<b>Title-Sujet</b> <b>Boundary Swing Bridge Replacement for Trent Severn Waterway National Historic Site</b>		
<b>Solicitation No. - No. de l'invitation</b> <b>5P468-22-0092/A</b>		<b>Date:</b> <b>August 25, 2022</b>
<b>GETS Reference No. – No de référence de SEAG</b> PW-22-01003050		<b>Client Ref. No. – No. de réf du client.</b> RPA 344
<b>Solicitation Closes – L'invitation prend fin :</b>		
<b>at – à</b> <b>2:00 PM</b>	<b>on – le</b> <b>Sept 08, 2022</b>	<b>Time Zone - Fuseau horaire</b> <b>HAE - EDT</b>
<b>F.O.B. - F.A.B.</b> <b>Plant-Usine: <input type="checkbox"/>    Destination: <input checked="" type="checkbox"/>    Other-Autre: <input type="checkbox"/></b>		
<b>Address Inquiries to: - Adresser toute demande de renseignements à :</b> <b>Sheldon Lalonde <a href="mailto:sheldon.lalonde@pc.gc.ca">sheldon.lalonde@pc.gc.ca</a></b>		
<b>Telephone No. - No de téléphone</b> <b>343-585-3836</b>		<b>Fax No. – No de FAX:</b> <b>1-855-983-1808</b>

## **AMENDMENT #3**

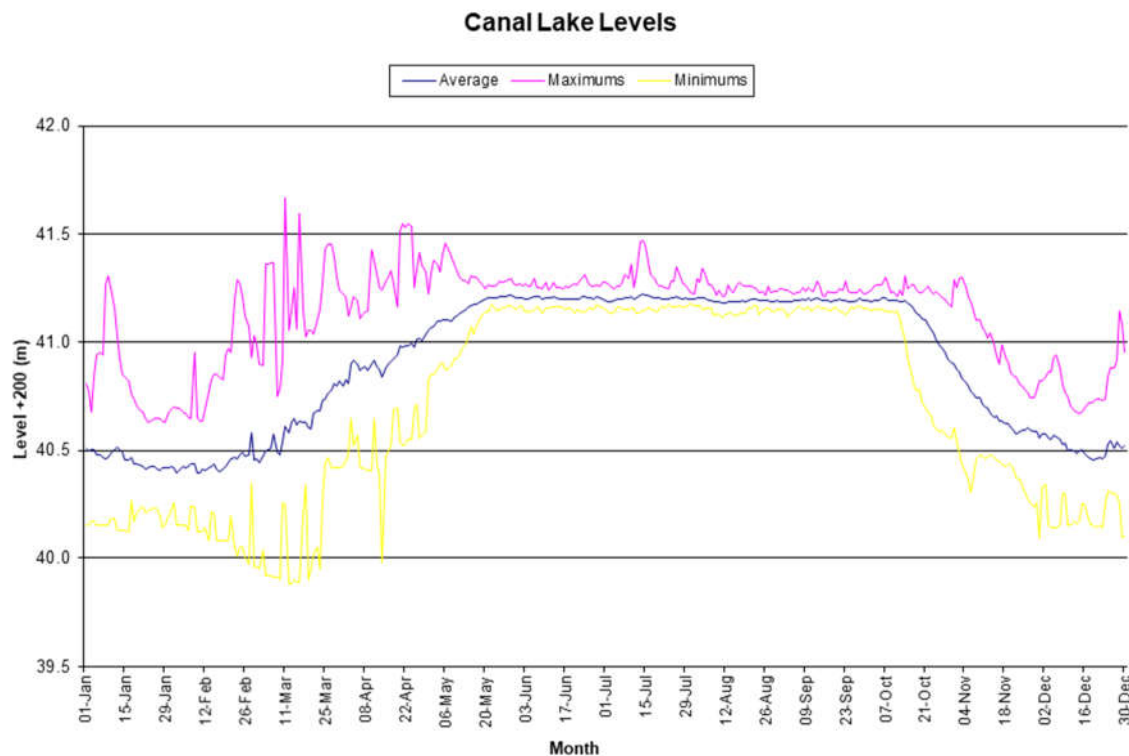
In order to design a suitable cofferdam solution, please provide a geotechnical report for the project?

As it relates to cofferdam design, to support the contractor's planning and implementation of the Boundary Road Bridge replacement construction work, Parks Canada advises of the following expected water levels and flows at the Boundary Road Bridge.

#### **Cofferdam Design Data**

- 1/20-year flow rate - 60cms
- 1/20 water level - 241.6m

#### **Normal Water Data**

- Summer Navigation High 214.25m
- Summer Navigation Low 241.15m
- Winter Navigation High 241.1m
- Winter Navigation Low 240.4m

The above data comes from the historical rule curve found below for the water levels gauged at Bolsover Dam 37. Note that upstream of the bridge water levels may be slightly higher but the variance should not be extreme.

Parks Canada requests a minimum cofferdam crest elevation of 241.9m however the freeboard allowance shall be subject to the design engineer's discretion and submitted rationale. Boats that proceed rapidly through the bridge can generate a significant wake. Waves should be calculated by the Contractor's Engineer. The US Army Corps of Engineers dimensionally homogeneous equation is a common acceptable method. Climatic Data for wind speed in the area is available in sources such as the highway bridge design or building codes.

Given the downstream dam's hydraulic capacity, the 60cms flow should be assumed possible at navigation low water level to produce a conservative velocity and corresponding shear stress/drag force on the cofferdam.
